## Addendum No. 4

City of Coquitlam

RFP No. 23-042

### Percy Perry Track and Field Renewal

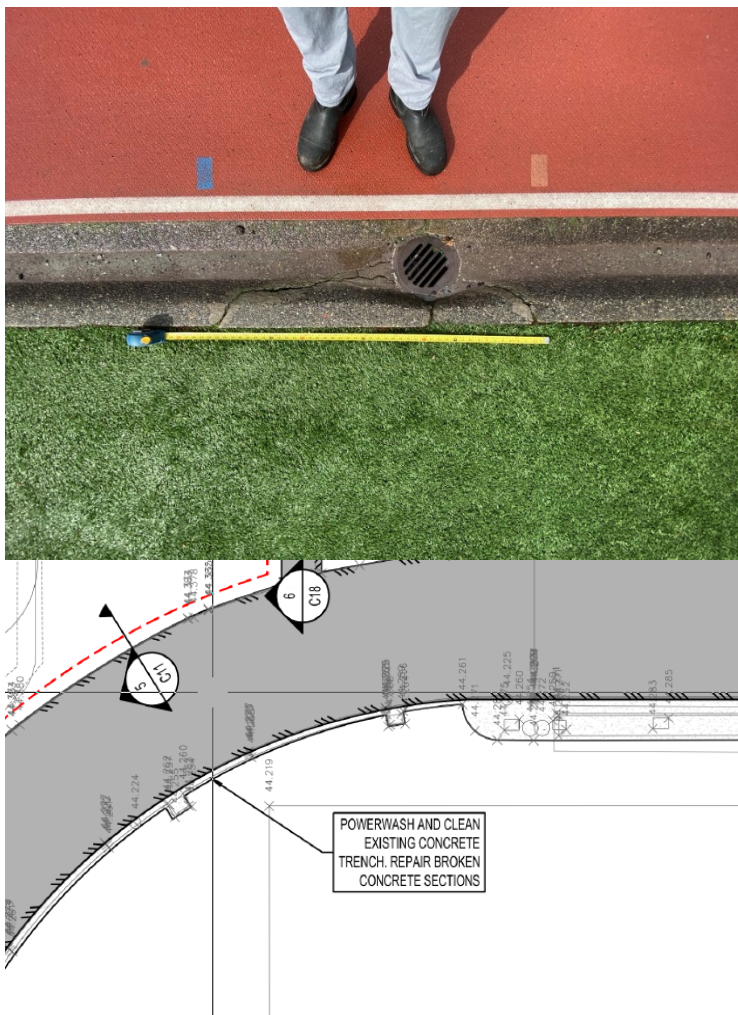
- Q4. Can you identify and quantify the repair needed on the existing concrete trench drain, as mentioned on C6?
- A4. Contractor is to plan for repairing twelve concrete sections, each approximately 1 meter long, that will be identified in the field. The scope of repairs will be to remove damaged sections of the existing concrete trench to sound material, clean and prepare the adjoining surfaces with a permanent bonding agent, and replace the section with new cast in place concrete to match the existing dimensions and finish as closely as possible. Existing area drains in the trench edger will remain as is. It is recommended that Proponents review the existing site conditions prior to the submission deadline. However, an example of a typical damaged section that will require repair is shown below. Note that repairs are not required in replaced sections of track if Optional Item 4.0 proceeds.**

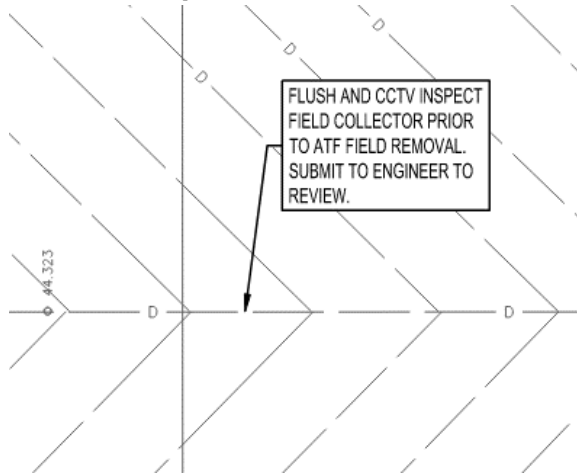
Q5. Can you confirm that it is only flushing of the existing lines that is required with no camera/video required?

**A5. The field collector shall be flushed and inspected by CCTV prior to ATF field removal as indicated on C7. Other lines flushed will not require video/camera inspection.**

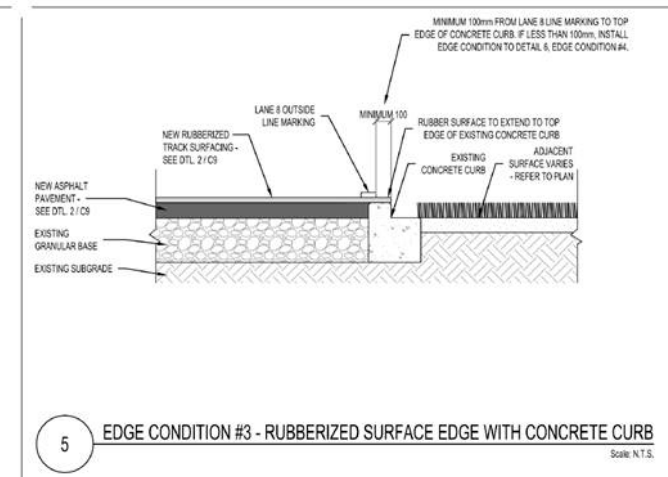
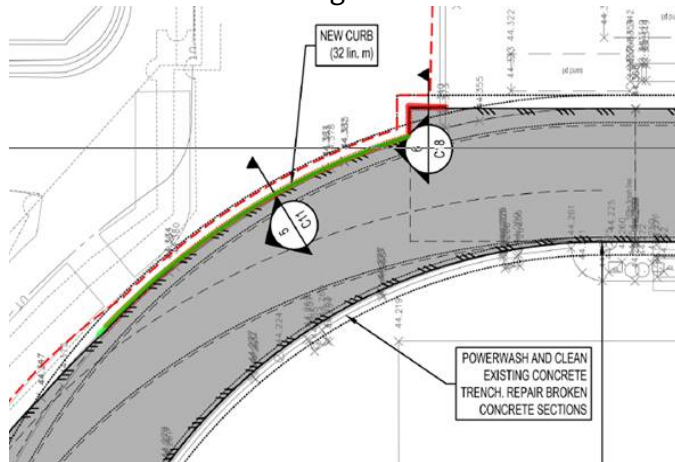
Q6. Are the junctions boxes that are shown to be moved on C16, only to be priced under item Optional price 4?

**A6. Yes.**

4 CONCRETE CURB DETAIL

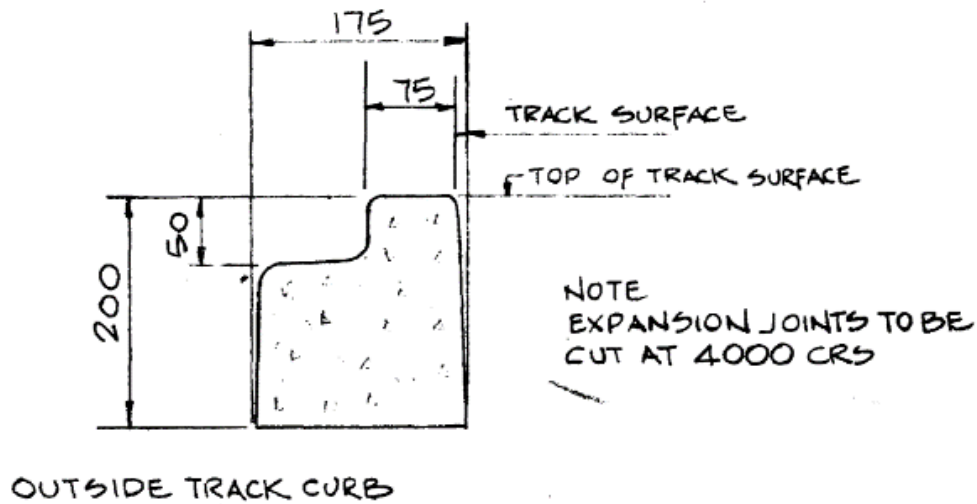
Q9. On C16 in the NE corner it calls for 32LM of curb as per detail 5 C11, can you provide the dimensions of the existing curb so we can match?

A9. See Drawing below:

Drawn	DVH	Sheet	
Date	MAY 2007		E03
Scale	AS SHOWN

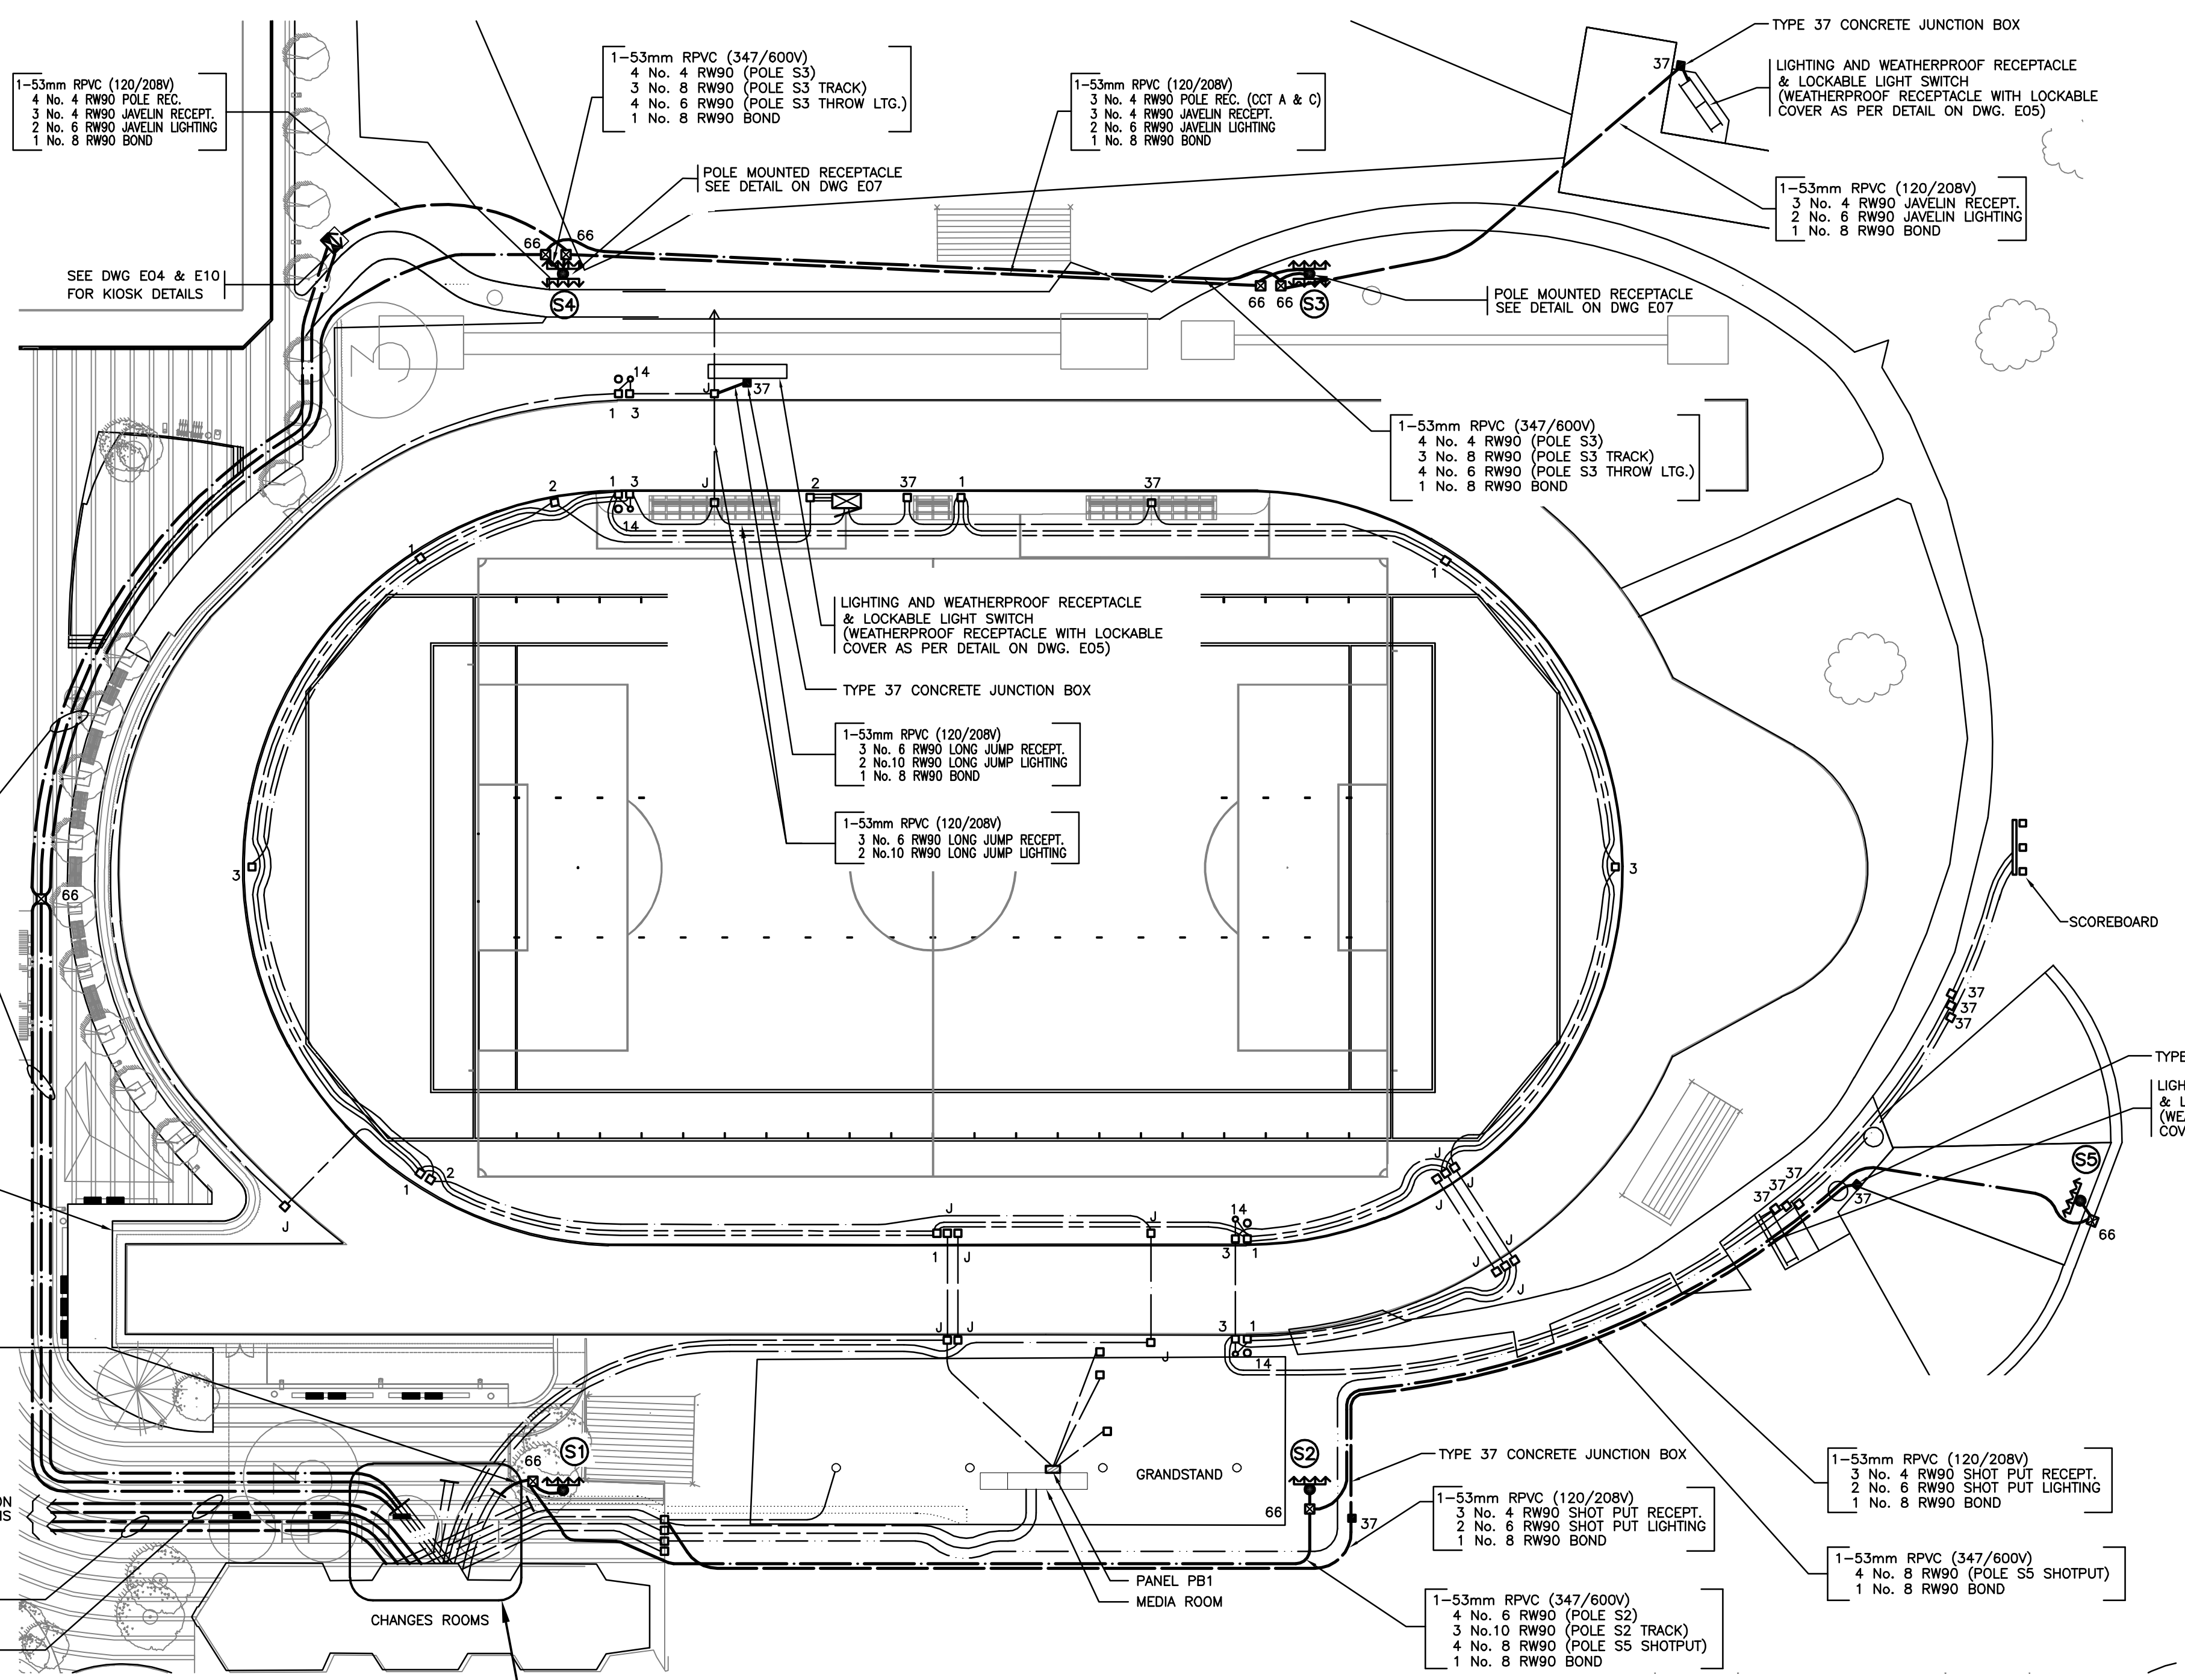
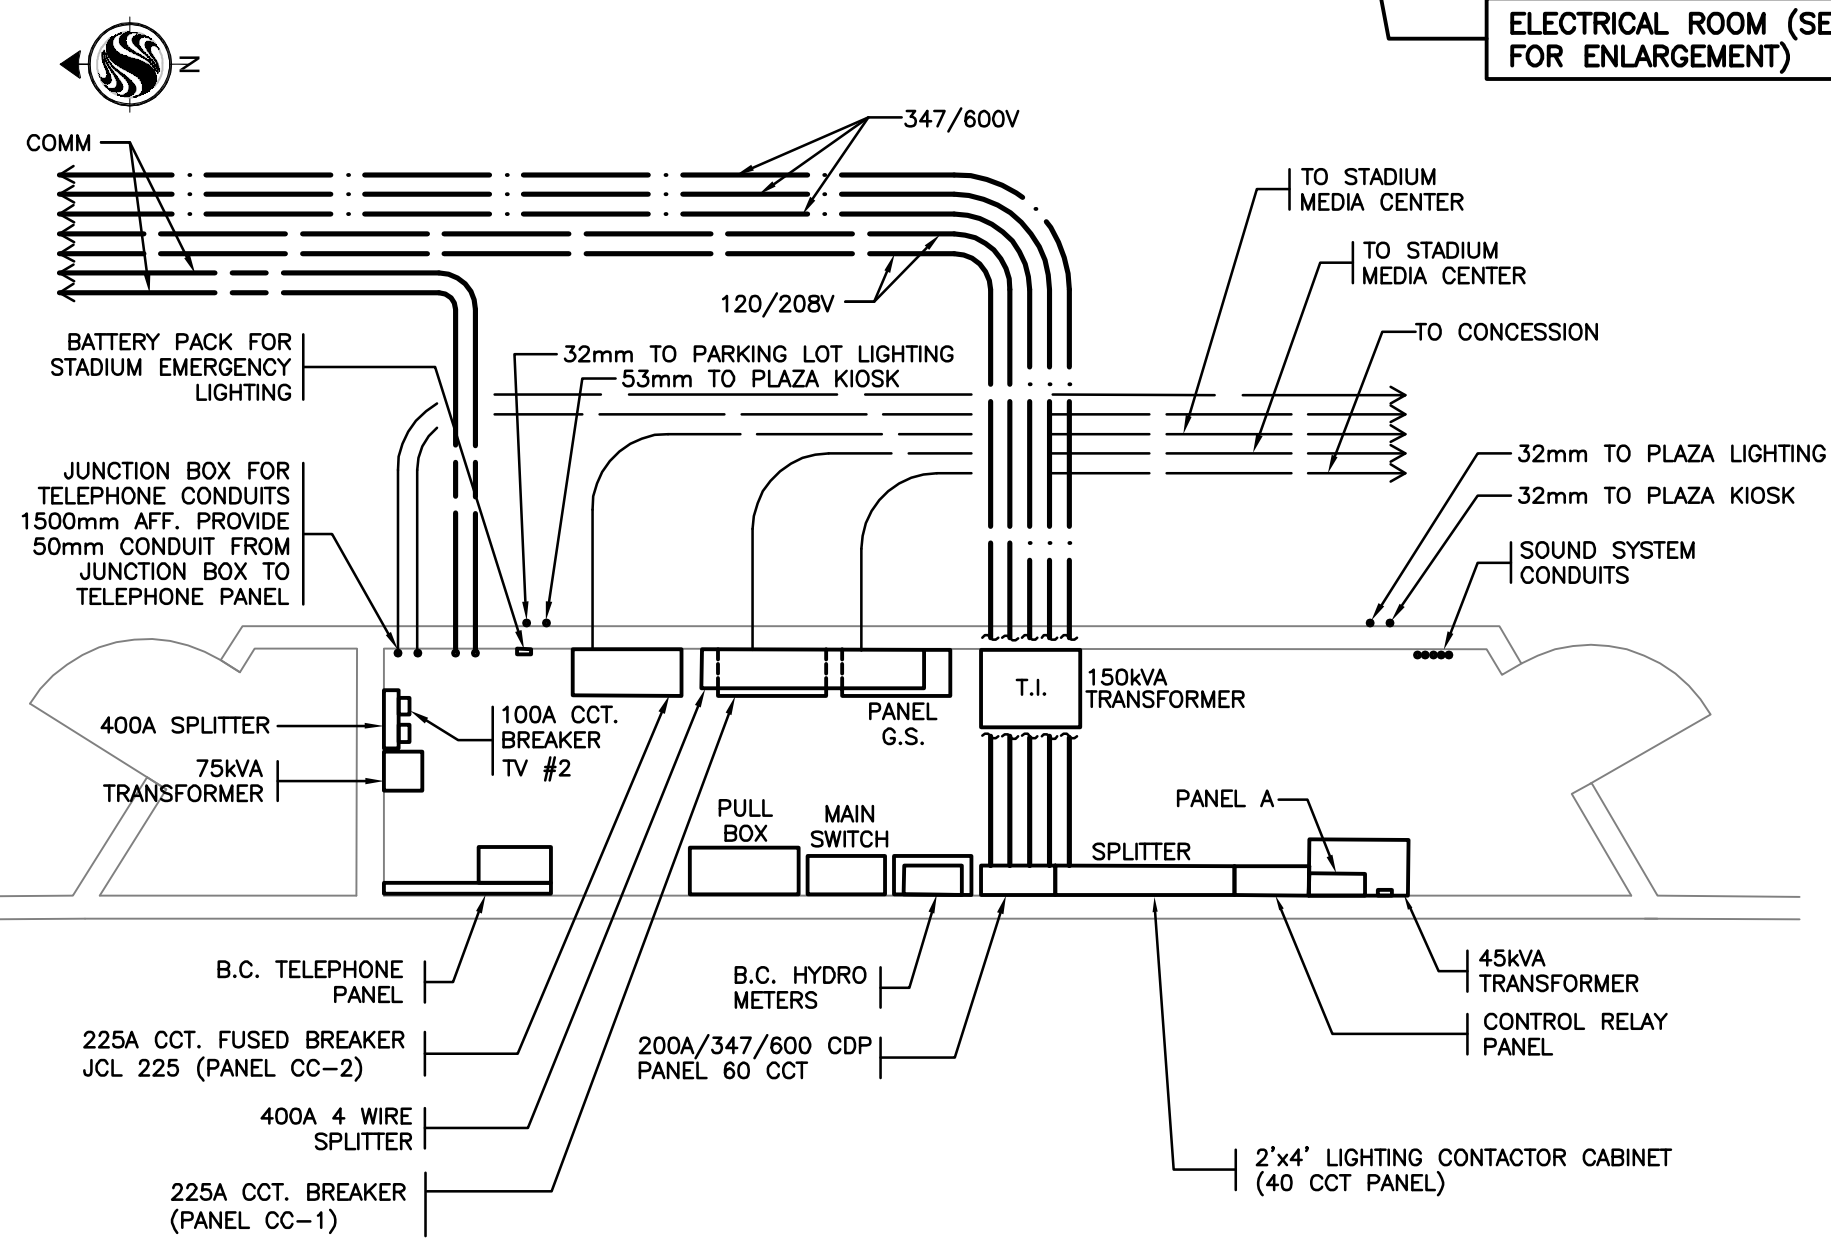
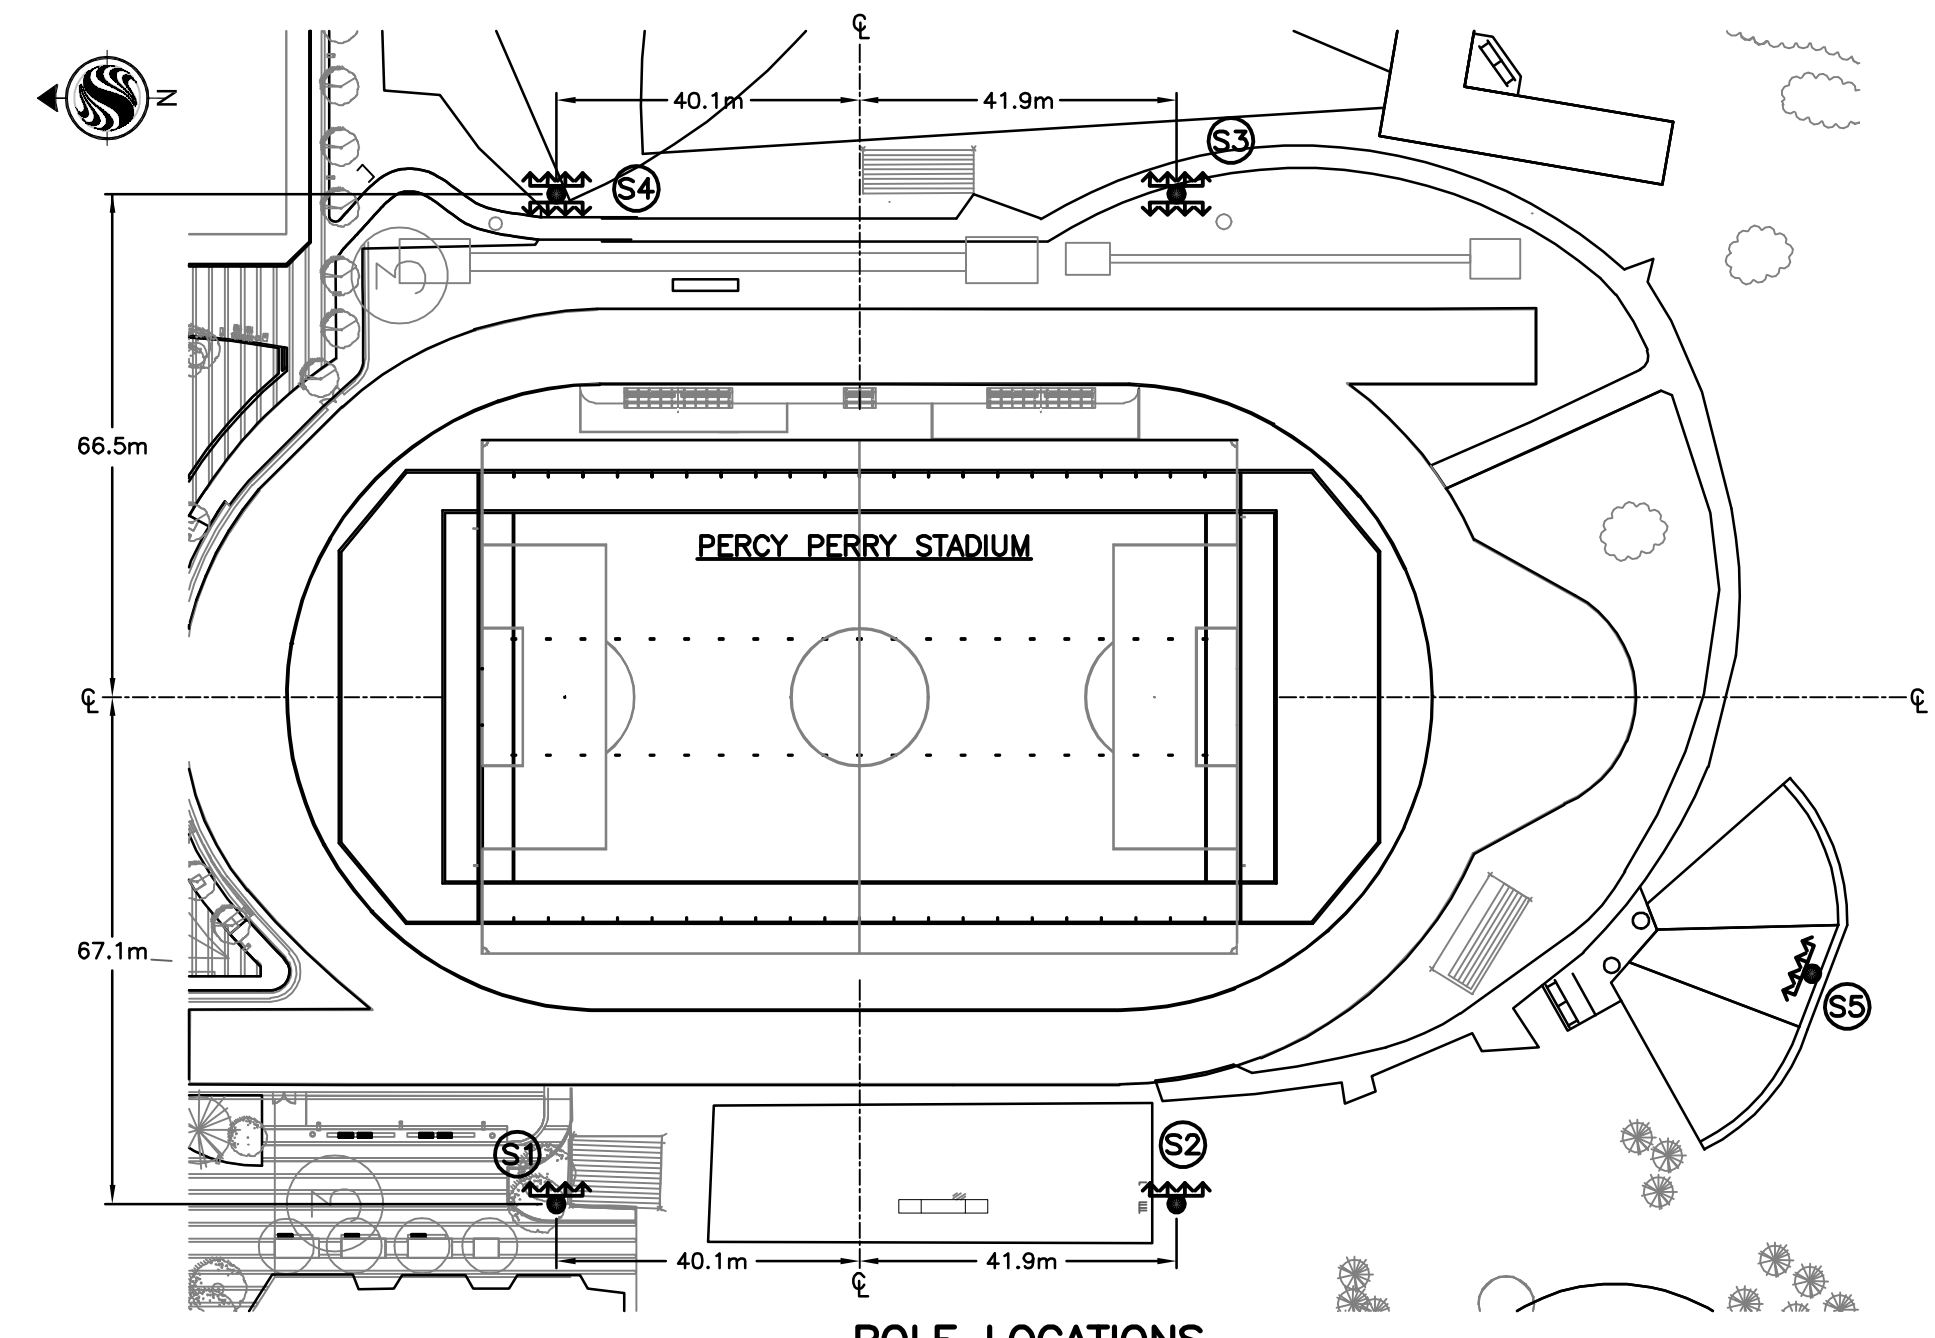
Q7. Are there electrical asbuilts available for the junctions boxes shown on C16?

**A7. Yes, refer to Drawing E03 – Stadium Lighting included as Attachment No. 1 to this Addendum No. 4.**
